TECHNICAL ADVISORY COMMITTEE REPORT

FILE NUMBER: 24-DP-52

SUBJECT: Preliminary Site Plan review for a Mixed Use Hotel with 3,500 Sq Ft of Commercial

space and 42 hotel rooms with rooftop amenities

A-2.5

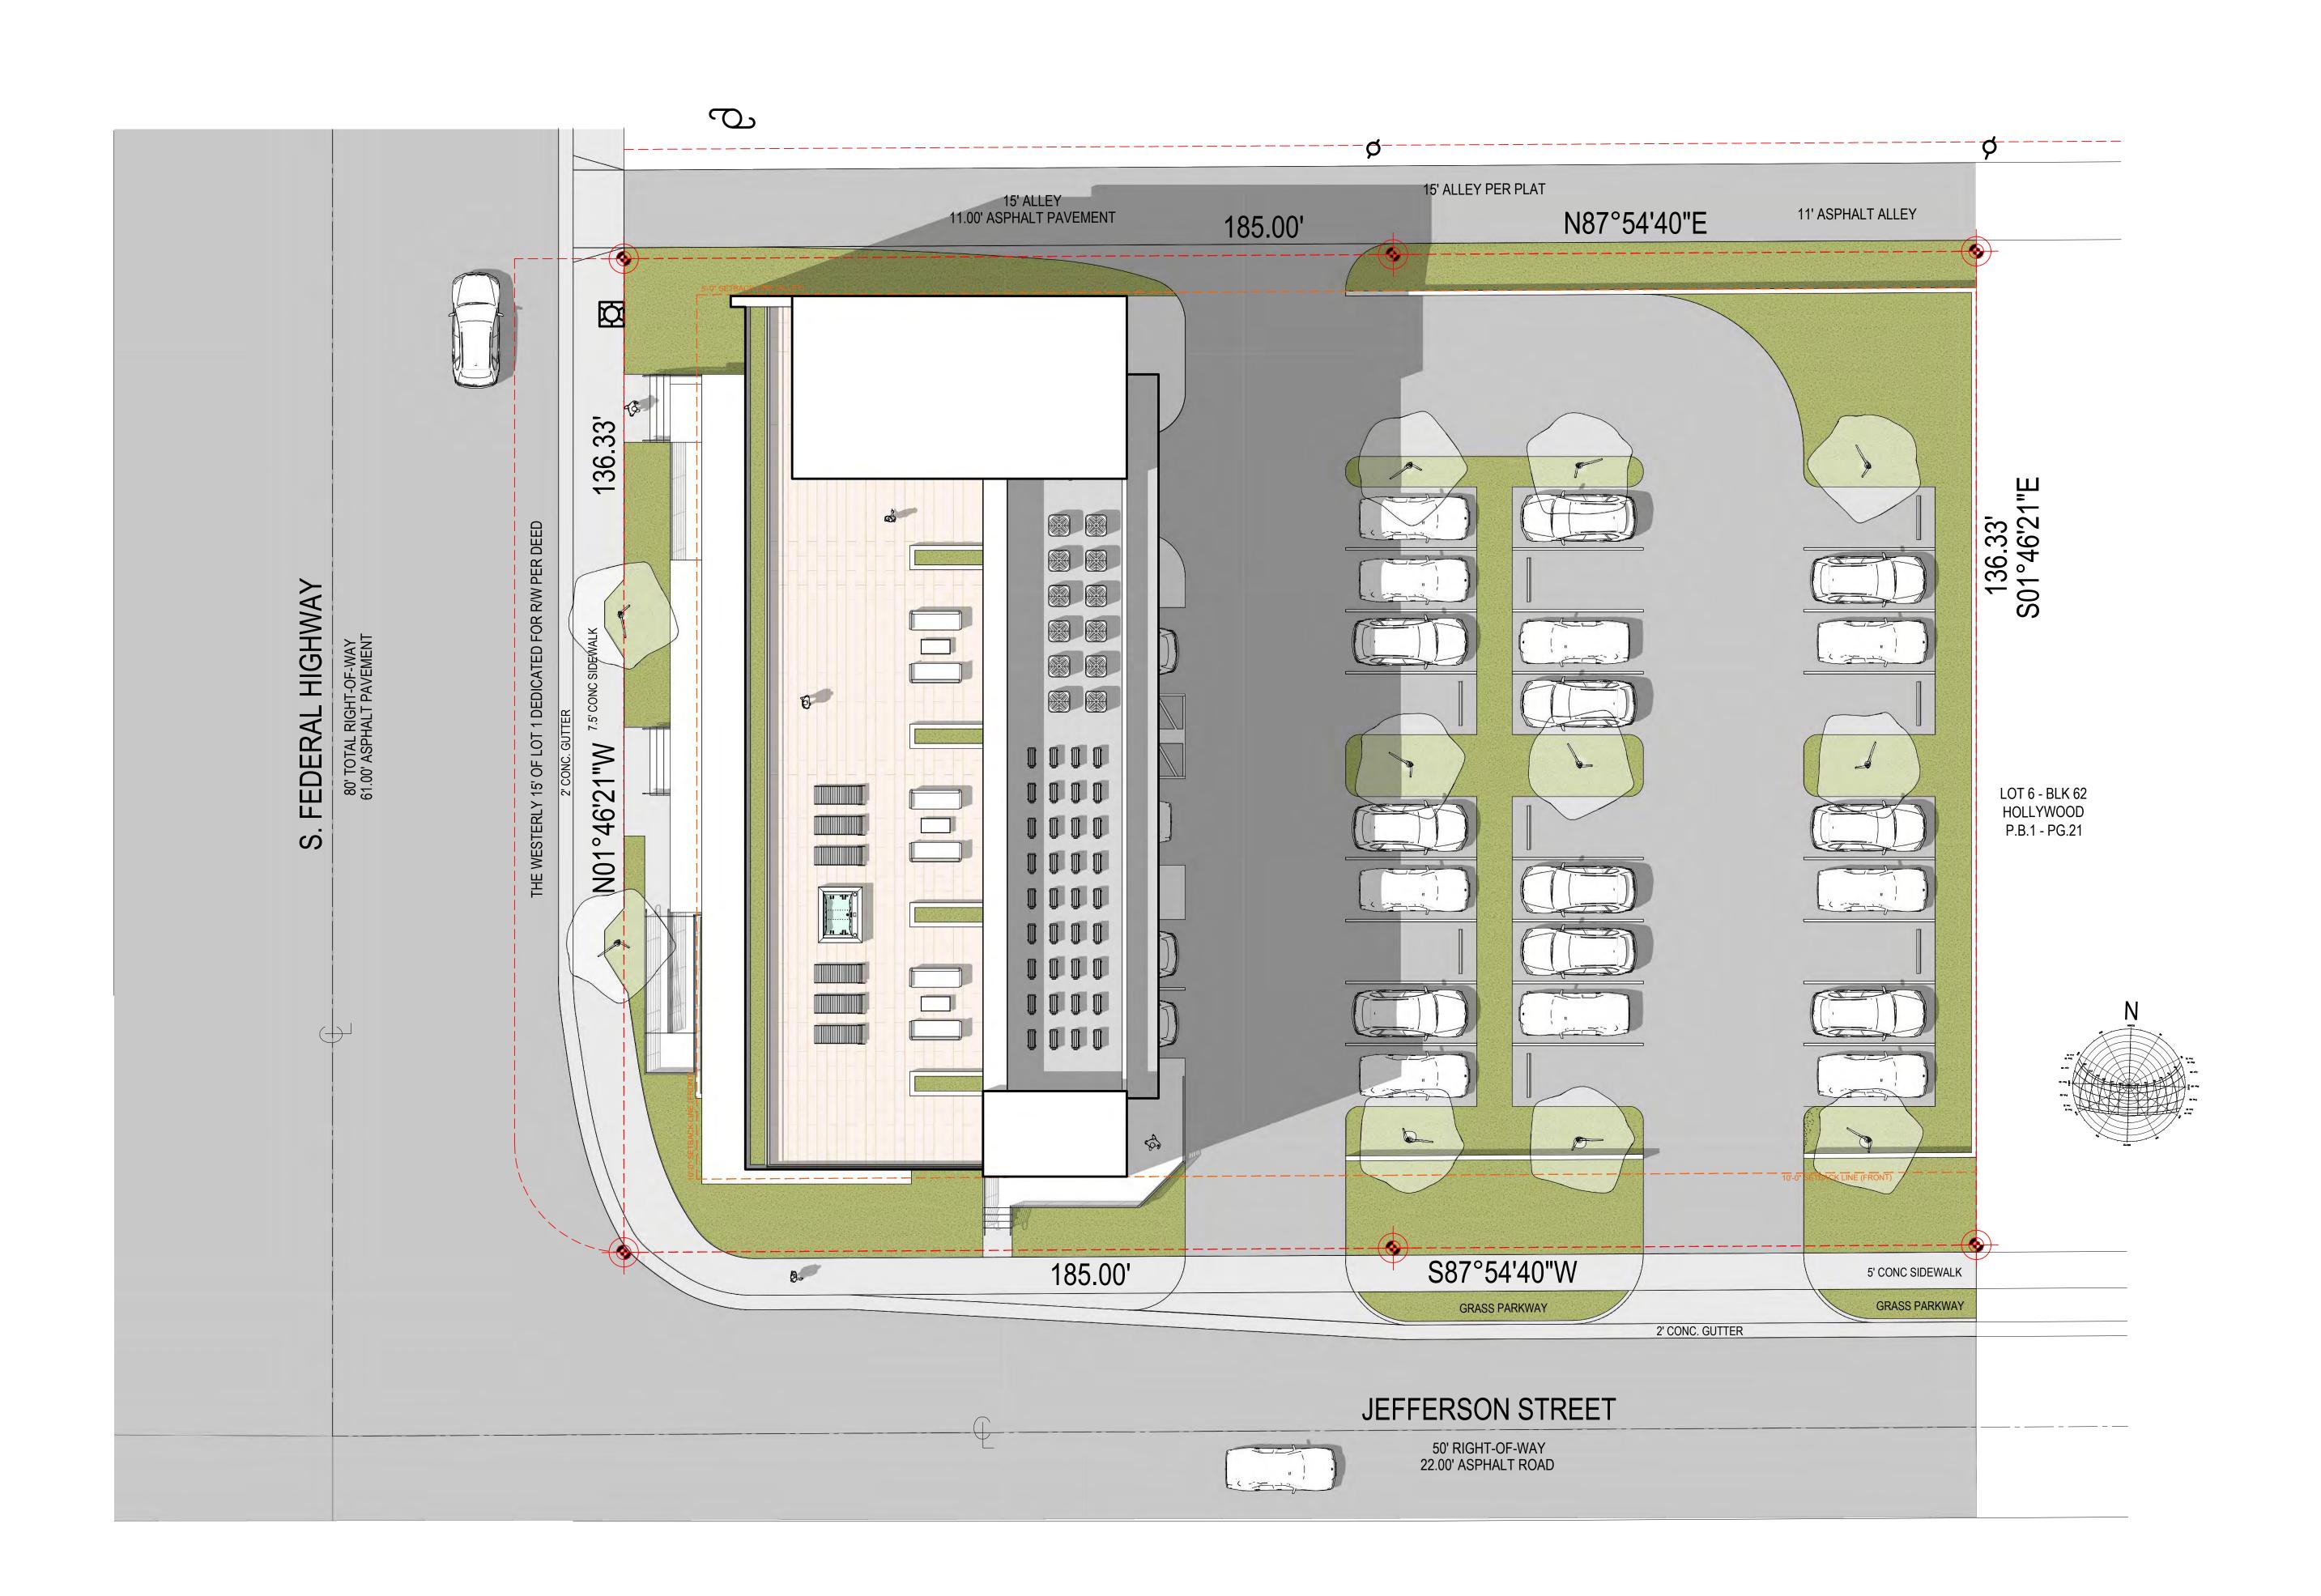
7 – The "BBQ" shown on plan pages A-2.5 and R-1.1 does not appear code compliant. --- Ensure compliance with the codes below are met, and gas appliances will not be approved (electric only with auto-off timers will be allowed).

Response: Understood. Please see attached revised architectural plans removing the BBQ grills.
